Generic design assessment of General Nuclear System Limited's UK HPR1000 nuclear reactor

Responses to the consultation on the generic design
assessment of the UK HPR1000

Date: July 2021

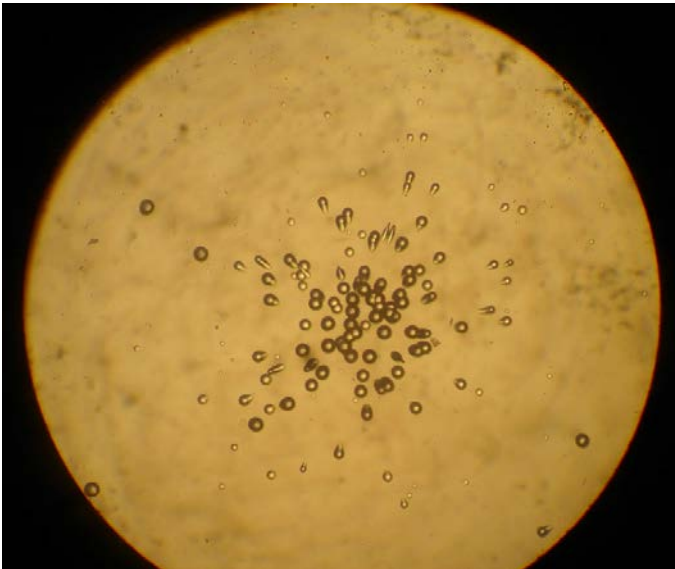
The report, commissioned by the charity Children with Cancer UK, explains a failure in the ICRP's concept of dose as an average across substantial volumes of body tissue. It argues that averaging is invalid in the case of exposure to particles of alpha-emitting elements that might be inhaled or ingested. This assertion is illustrated with an image (reproduced below and discussed on p 33 of the CwCUK report) showing the impact of individual tracks from alpha decays striking a sheet of CR39, which is conventionally used to detect radon, another alpha emitter. We remind the Agency that a tissue cell hit by a single alpha decay receives a radiation dose of 500mSv.

The CwCUK report suggests that this represents an anomaly in the concept of dose with the potential to explain the discrepancies between the frequency of health effects expected on the basis ICRP methodology and the incidence of cancer and congenital malformation that has been observed in association with the release of alpha-emitting particulates over many decades.

It may be thought that at doses as high as 500mSv the predominance of cell killing would negate any concern about health effects but we suggest that sublethal damage would also occur. During the CERRIE [2] process CoMARE's Chairman suggested that the Bragg effect would tend to create a zone of dead cells around a sublethally affected clone thus shielding that clone from the influence of protective signalling from healthy cells, leading to a deficit of apoptosis (programmed cell death).

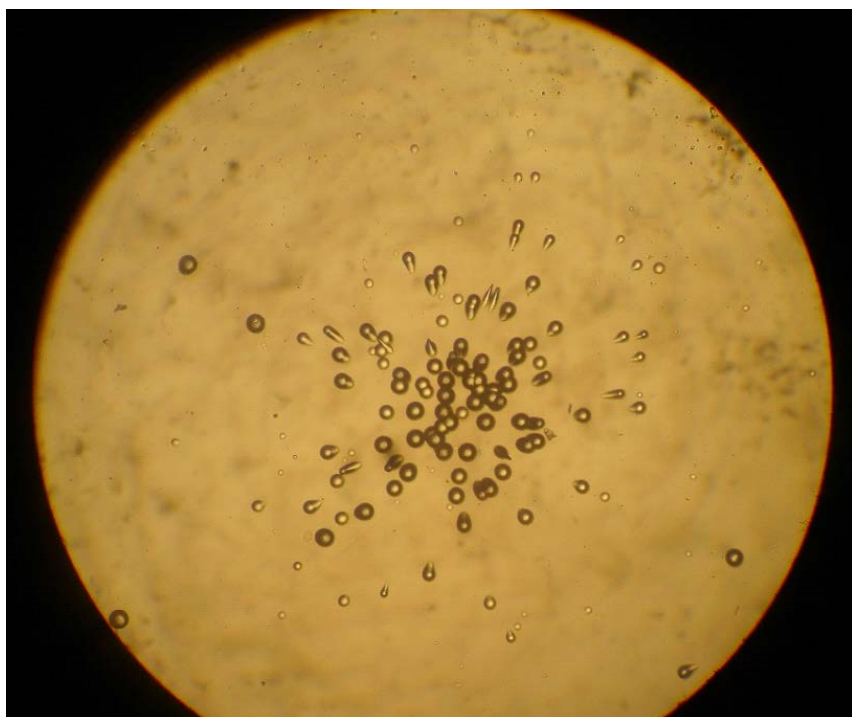
The report, commissioned by the charity Children with Cancer UK, explains a failure in the ICRP's concept of dose as an average across substantial volumes of body tissue. It argues that averaging is invalid in the case of exposure to particles of alpha-emitting elements that might be inhaled or ingested. This assertion is illustrated with an image (reproduced below, Figure 1, and discussed on p 33 of the CWCUK report) showing the impact of individual tracks from alpha decays striking a sheet of CR39, which is conventionally used to detect radon, another alpha emitter. We remind EA that a tissue cell hit by a single alpha decay receives a radiation dose of 500mSv. The CWCUK report suggests that this represents an anomaly in the concept of dose with the potential to explain the discrepancies between the frequency of health effects expected on the basis of ICRP methodology and the incidence of cancer and congenital malformation that has been observed in association with the release of alpha-emitting particulates over many decades.
